Clark & Enersen Project No.: 097-045-19  
LPS Bid #: 11090

### **ADDENDUM NO. 3**

Project: LPS New NW & SE Activities Complexes

Proposed Substitution: InLine Backstop Net System w/ #36 Netting

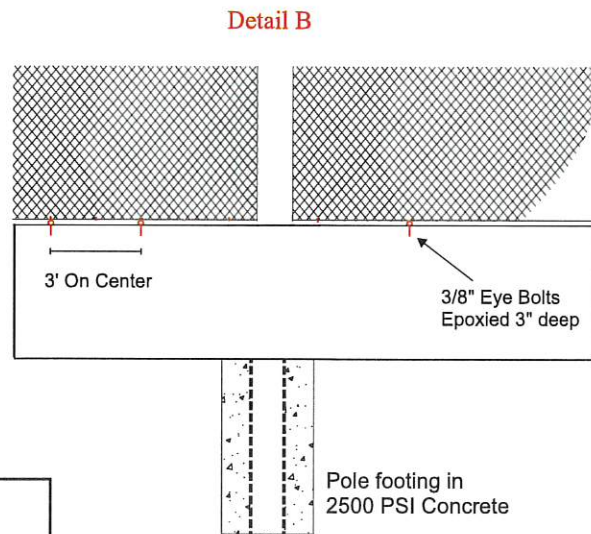
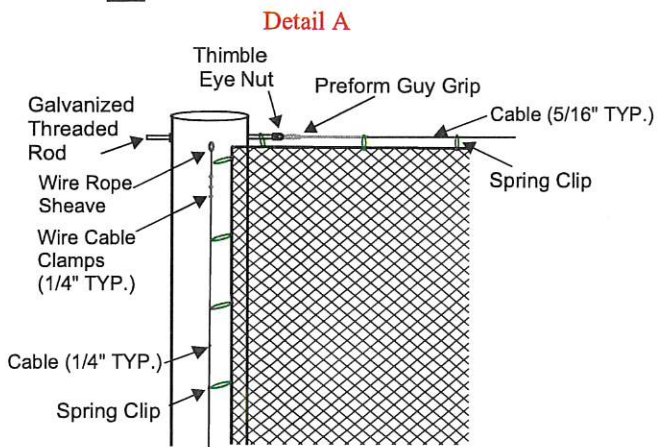
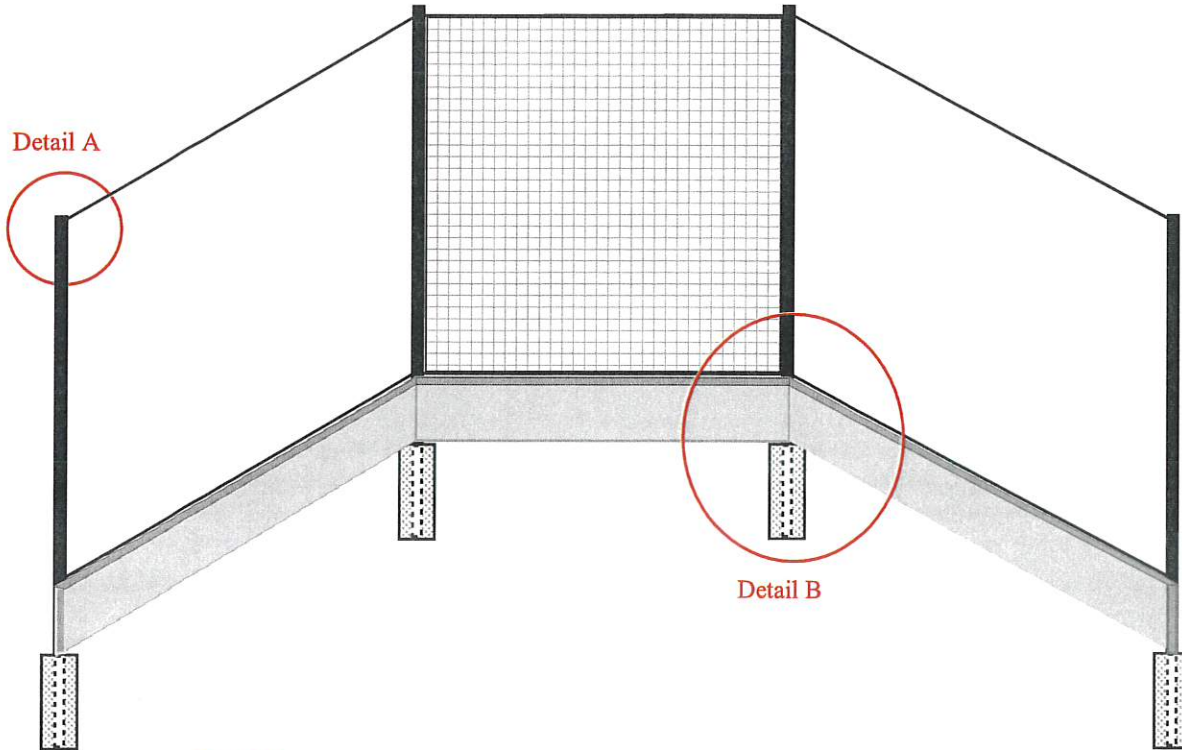
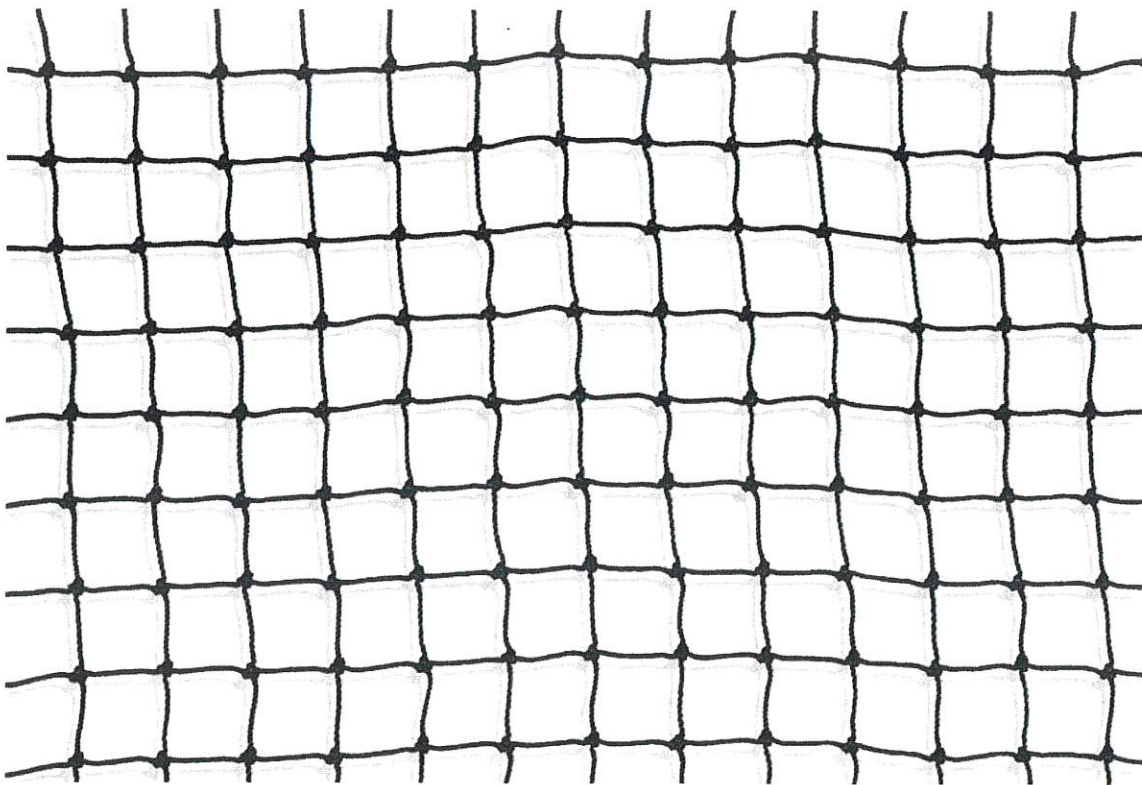
- Item 3-2:**      **Question:**  
Please see the attached Sports Field Equipment substitution Request.  
**Response:**  
The substitution request is approved.

Description: Pole to Pole Tension Net System

Refer to Paragraph 2.1.A; InLine Backstop Net System w/ #36 Netting / Unlimited Sports Solutions is an acceptable product/manufacturer.
